Docket No.: 52-011

AR-07-0801

Southern Nuclear Operating Company  
Vogtle Early Site Permit Application  
Response to Requests for Additional Information Letter No. 6 Involving Geology/Seismology

**Response to March 15, 2007 RAI Letter No. 6**

SSAR Figure 2.5.1-14

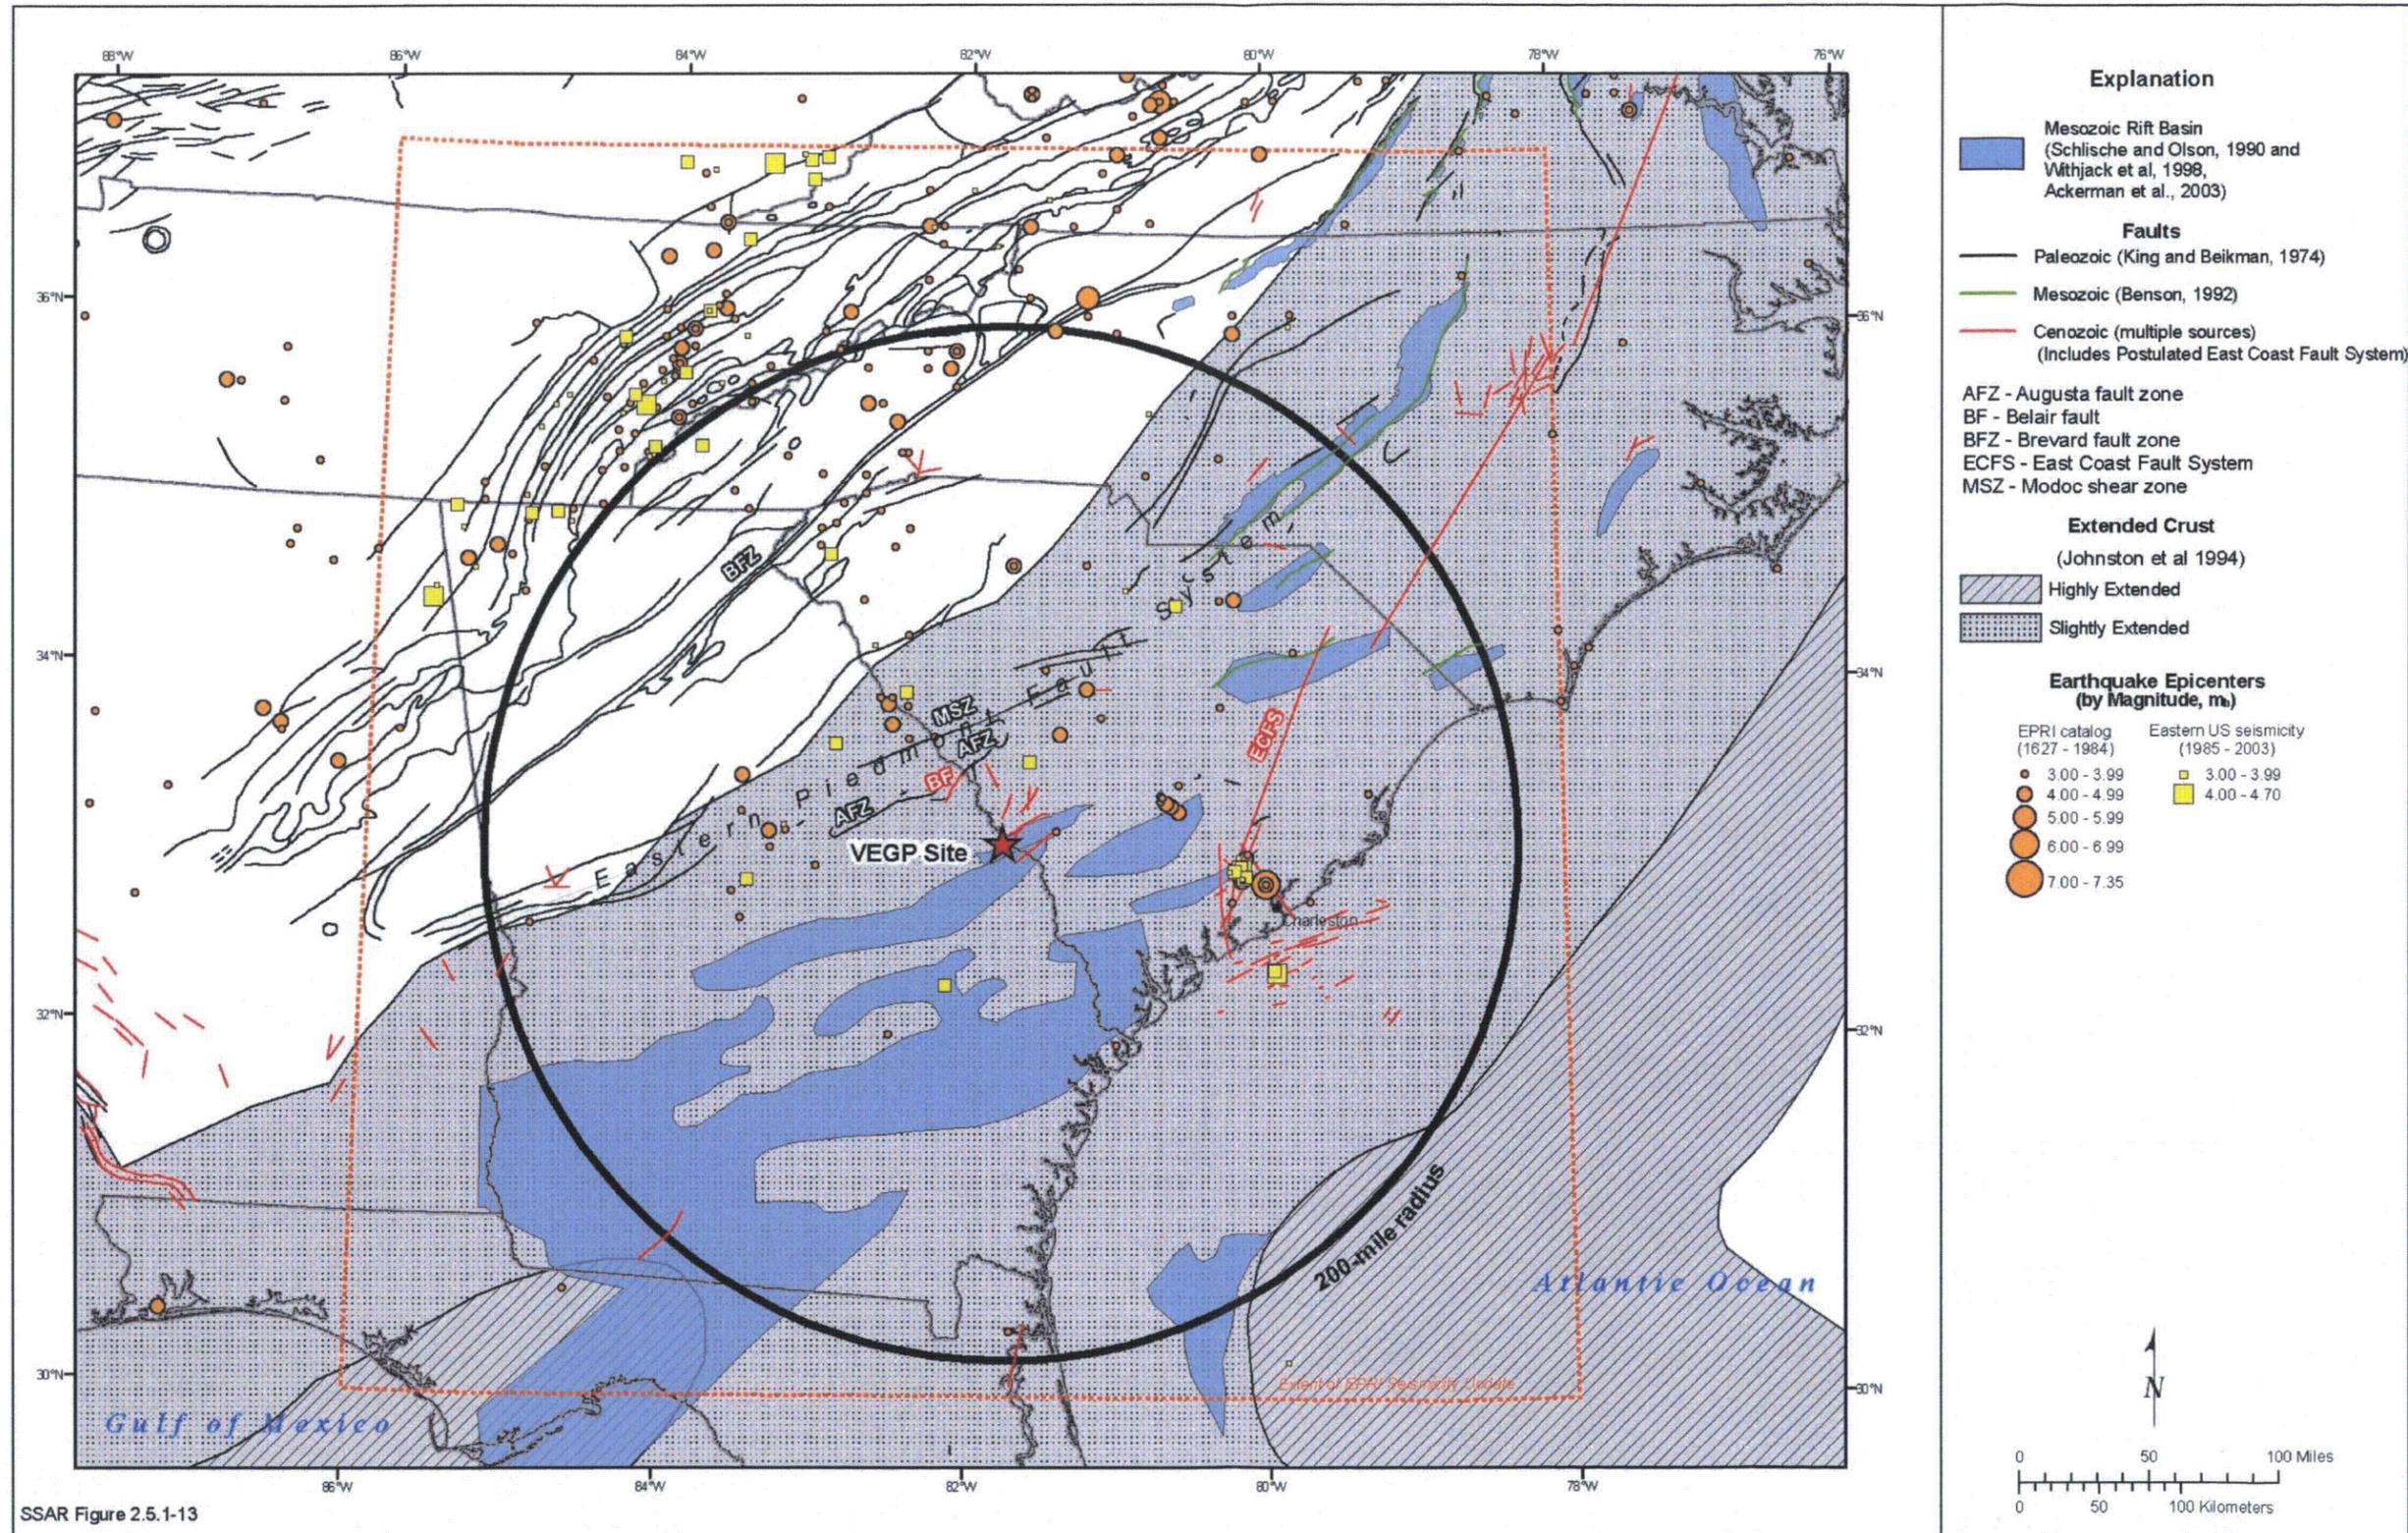
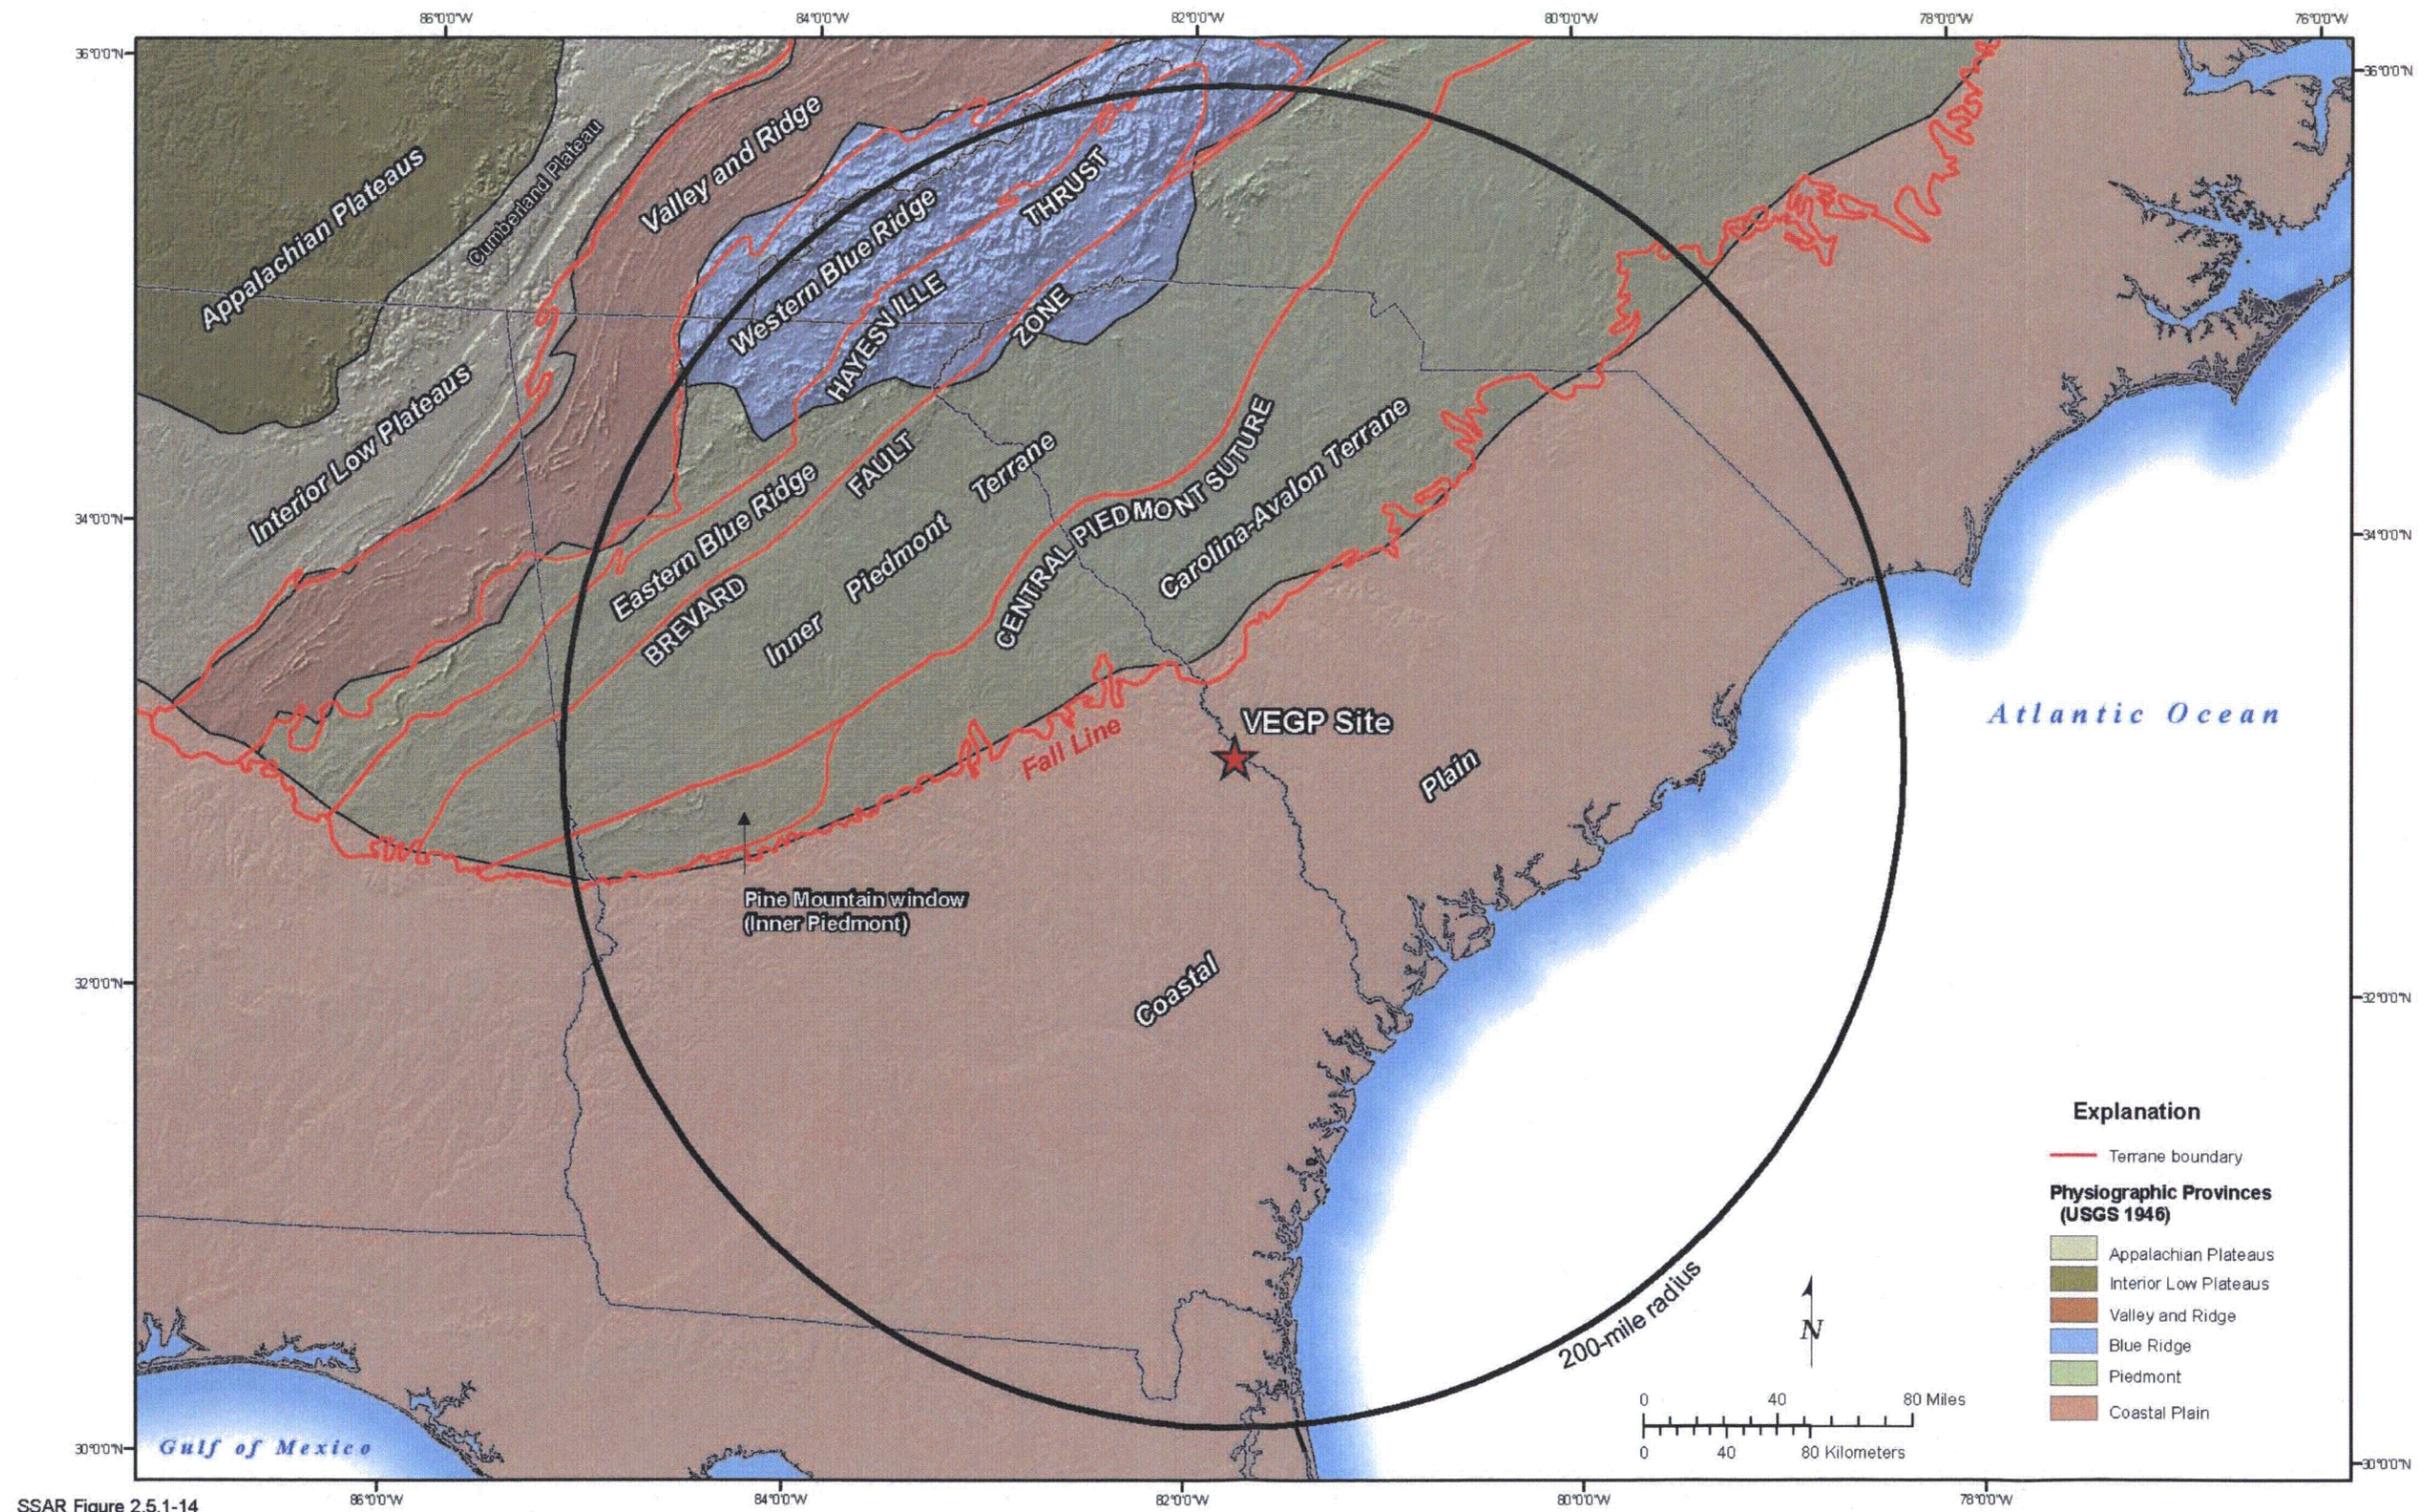
**2.5.1-6 For faults listed under “Other Paleozoic Faults” in SSAR Section 2.5.1.1.4.3, the Central Piedmont Suture and the Eastern Piedmont Fault System are not shown in Figure 2.5.1-14.**

**Please correct Figure 2.5.1-14 to include these two faults since others listed are shown therein.**

The reviewer is correct. The Central Piedmont suture and the Eastern Piedmont fault system are discussed in the text, but are not labeled on figures. This will be corrected in next revision of the ESP application.

The Eastern Piedmont fault system will be labeled on SSAR Figure 2.5.1-13 and the Central Piedmont suture will be labeled on SSAR Figure 2.5.1-14, as shown on the revised figures following this response. References to these figures in the text will be changed accordingly.
